<b>DOCKETED</b>	
<b>Docket Number:</b>	23-AFC-01
<b>Project Title:</b>	Morton Bay Geothermal Project (MBGP)
<b>TN #:</b>	254603
<b>Document Title:</b>	Morton Bay Geothermal Project CURE Data Response Set 4 (Responses to Data Requests 252 to 279)
<b>Description:</b>	N/A
<b>Filer:</b>	Lindsey Xayachack
<b>Organization:</b>	Jacobs
<b>Submitter Role:</b>	Applicant Consultant
<b>Submission Date:</b>	2/21/2024 2:28:42 PM
<b>Docketed Date:</b>	2/21/2024

# CURE Data Response Set 4 (Responses to Data Requests 252 to 279)

Morton Bay Geothermal Project  
(23-AFC-01)

<b>Figure DRR-272 Agricultural Return Flows.....</b>	<b>9</b>
--	----------

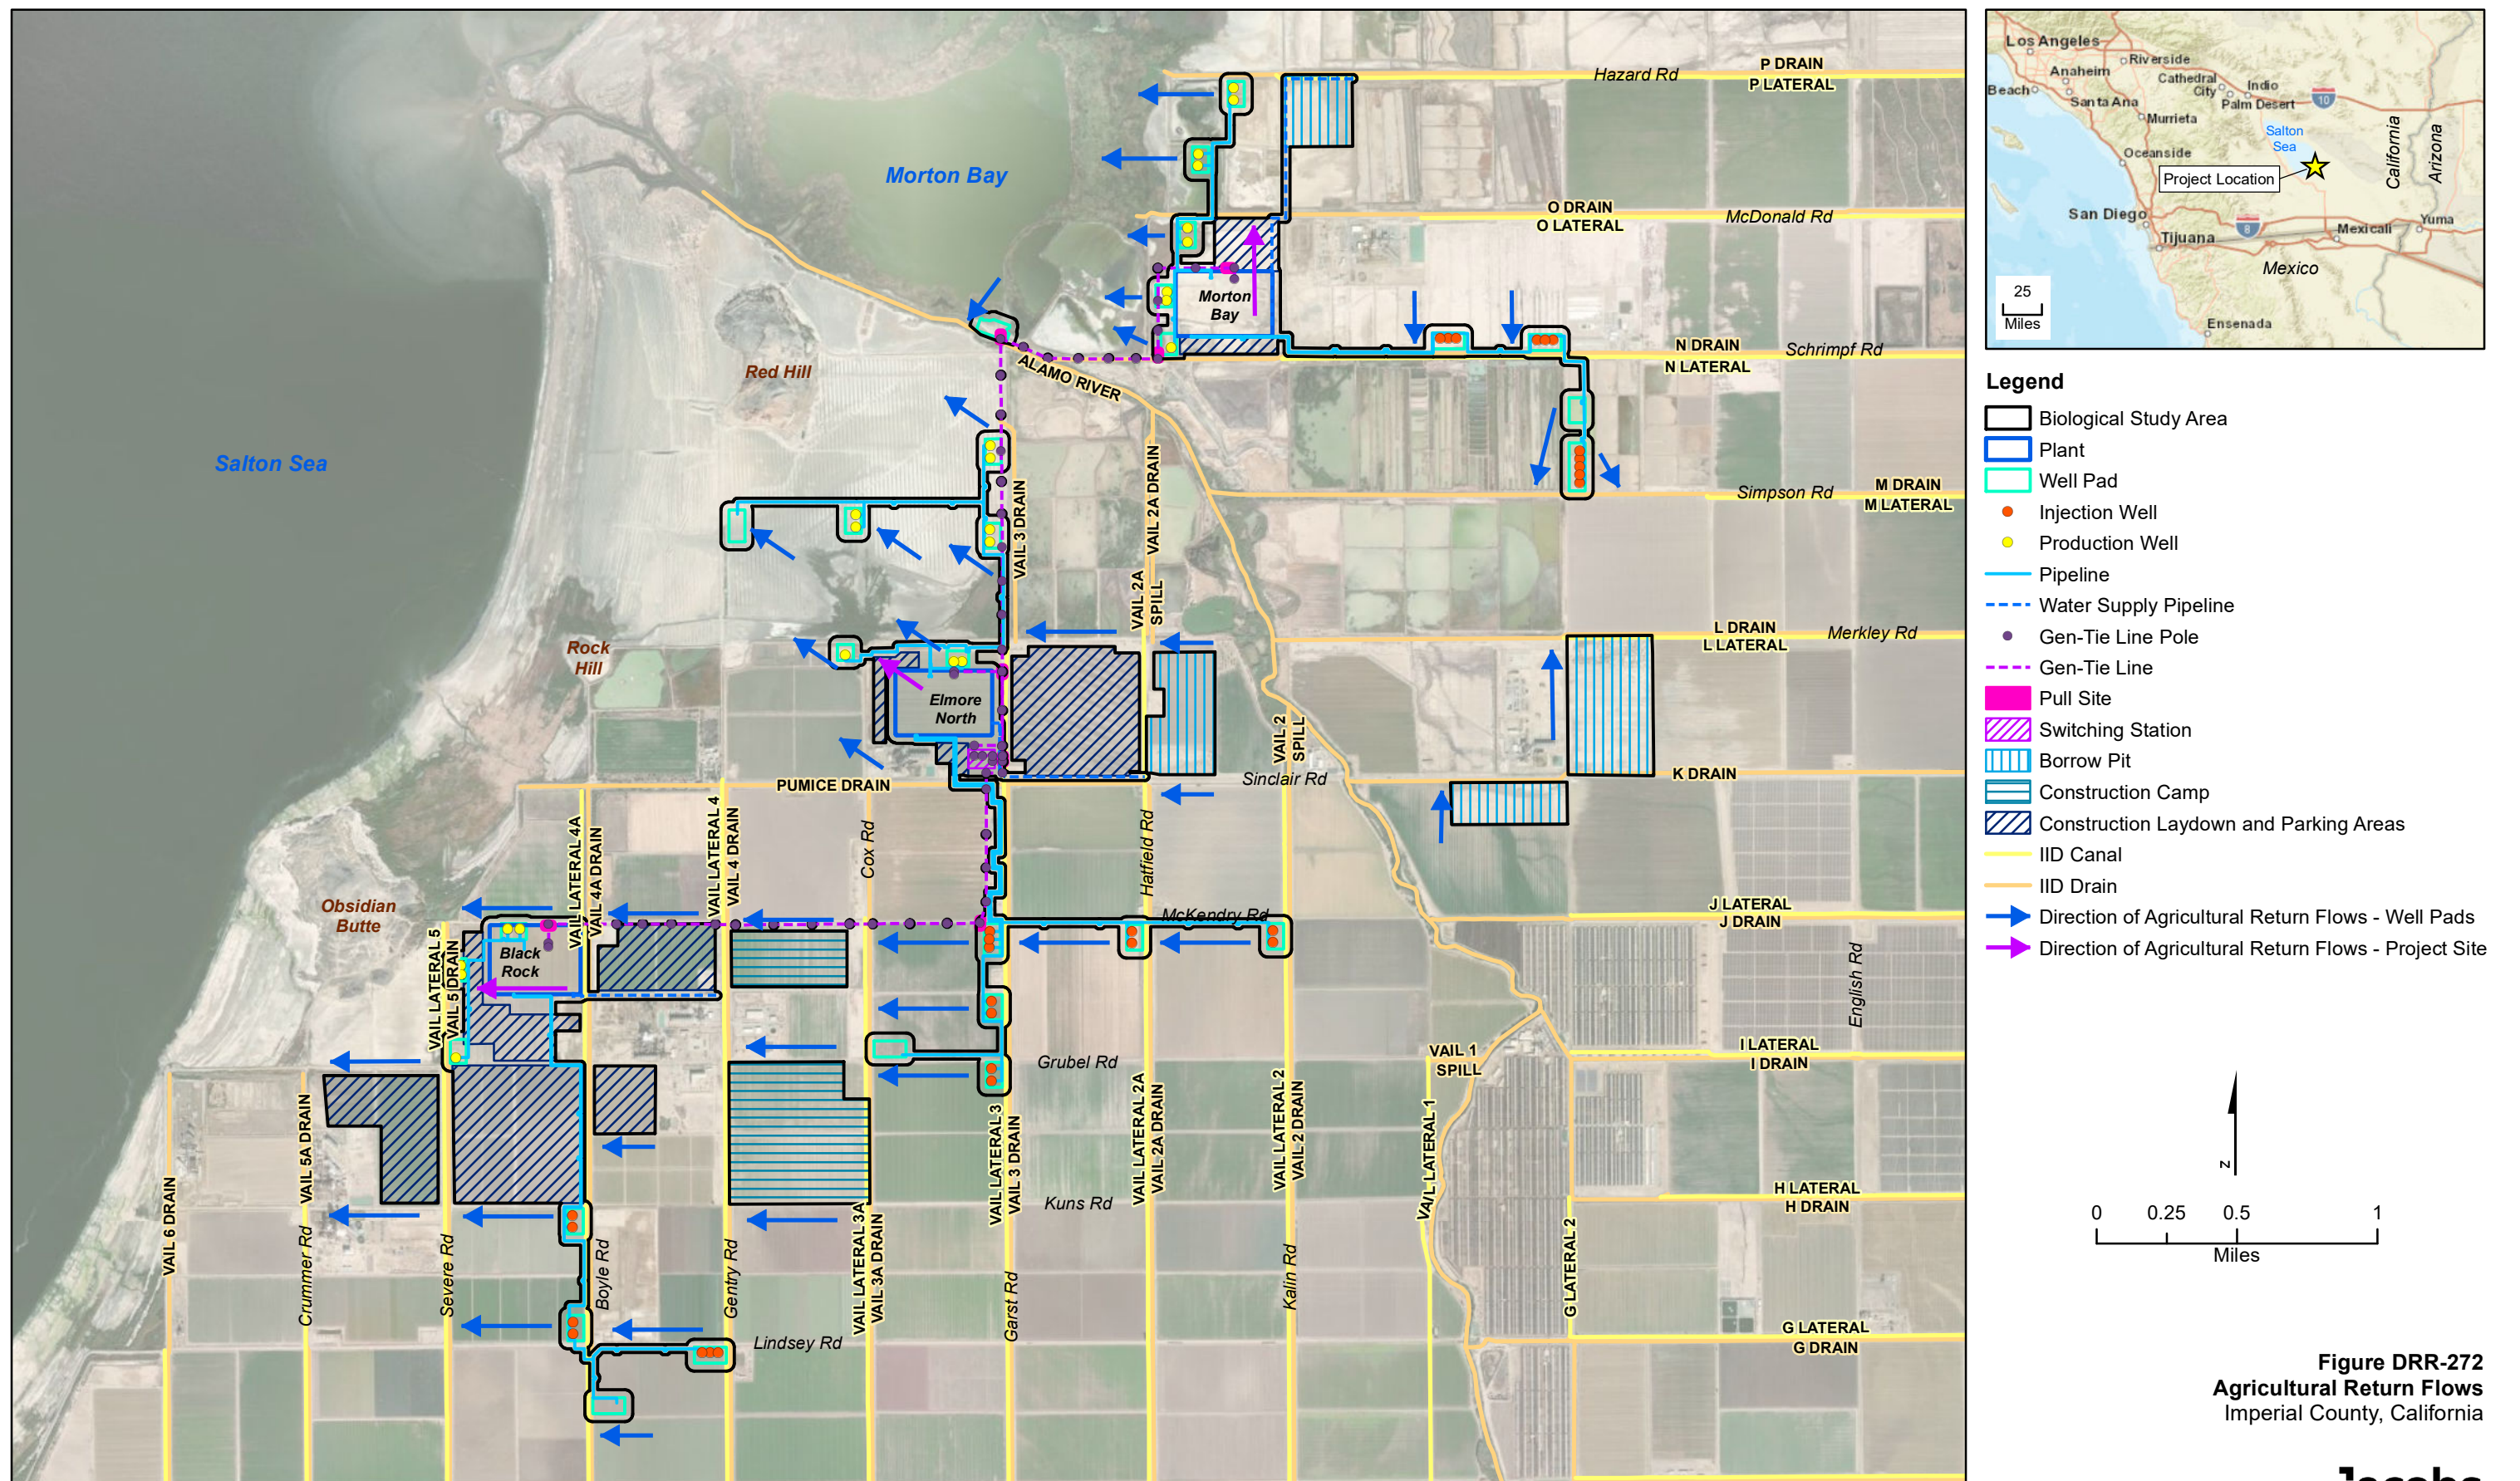
*CURE Data Request Set 2 No. 183 asked the Applicant to provide a map that identifies the path of agricultural return flows (irrigation runoff) from the agricultural fields that would be impacted by the Project. In response, Figure DR 183 shows the agricultural return flows from the proposed Project plant site, but not from any of the other agricultural fields that would be impacted by the Project. (TN 254015)*

272. *Provide maps that identify the path (including receptor drains) of agricultural return flows (irrigation runoff) from all agricultural fields that would be impacted (permanently or temporarily) by the Project (i.e., fields that will be impacted by the proposed well pads, laydown areas, borrow pits, and construction camp).*

**Response:** Figure DRR-272 identifies all project components along with existing agricultural return flows. Flows from the plant site drain towards the IID O Drain (located north of the project site). Flow directions from all other project components are as shown.
